CONTENTS

APPENDIX 14

14A ANSWERS TO QUESTIONS

FIGURE 14A.21-1  
 AVERAGE MODERATOR  
 TEMPERATURE VERSUS TIME

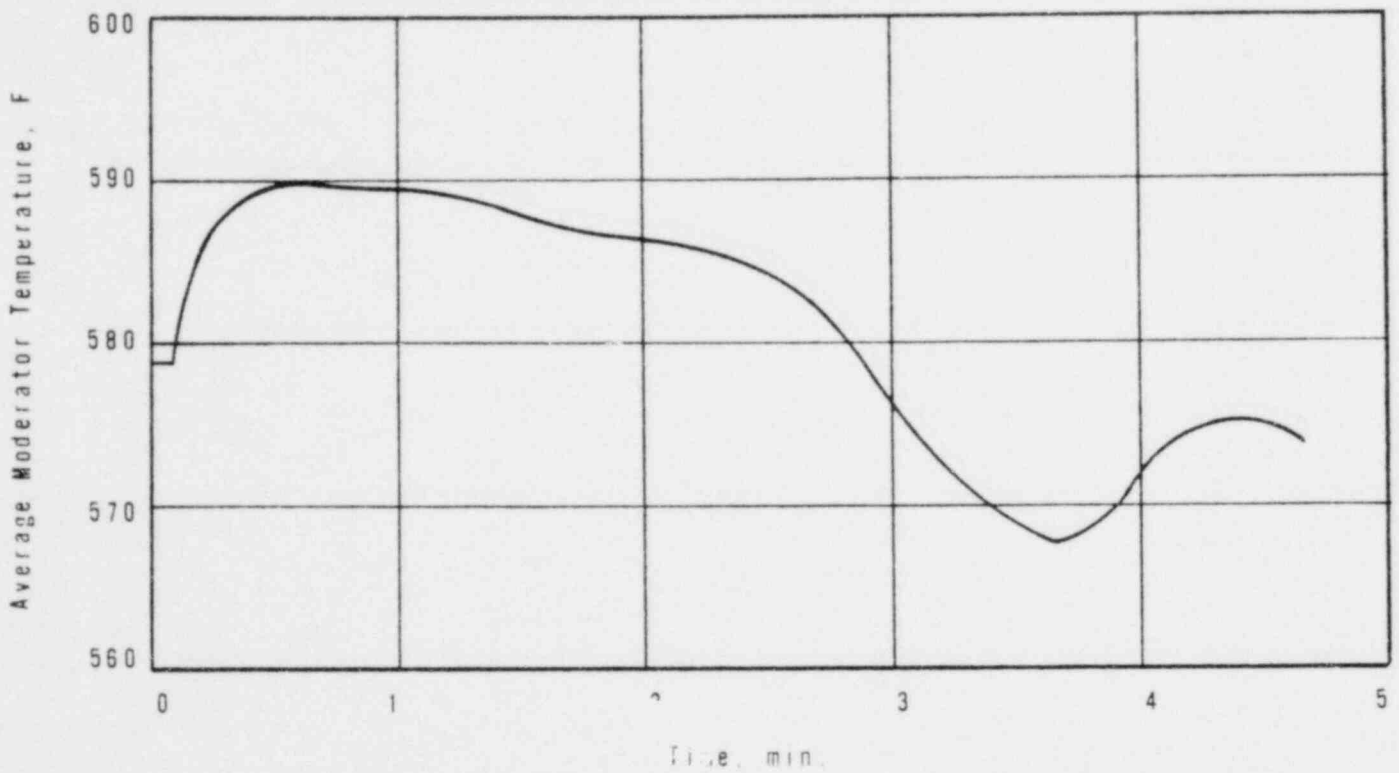
QUESTION Provide the following results of your analysis of the load loss  
14A.21 transient.

Figures 14A.21-1 through 14A.21-4 show average moderator temperature, system pressure, reactor thermal power, and fuel average temperature and clad average temperatures for a typical loss of load transient. These data are based on a turbine trip from full load. The moderator coefficient of reactivity is taken as zero for these set of data.

FIGURE 14A.22-1  
REACTOR COOLANT SYSTEM  
NATURAL CIRCULATION  
CHARACTERISTICS

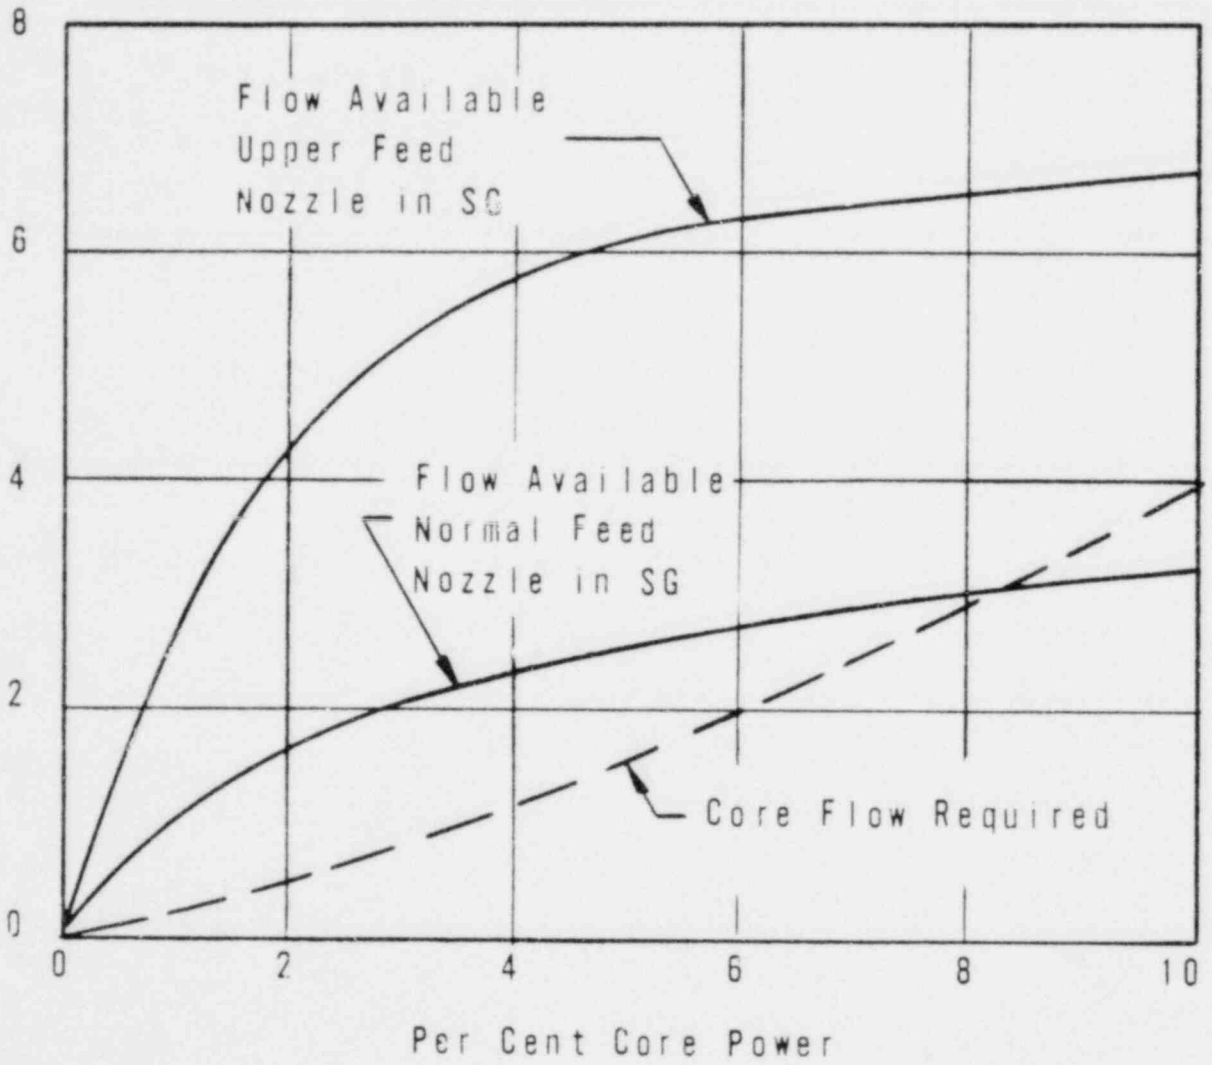
QUESTION 14A.22 Describe the natural circulation characteristics of the primary loop system. Will operation of primary loop relief valves, due (DRL 14.3) to its deadband characteristics, affect this flow?

ANSWER Figure 14A.22-1 shows the natural circulation flow characteristics of the reactor coolant system as a function of power level.
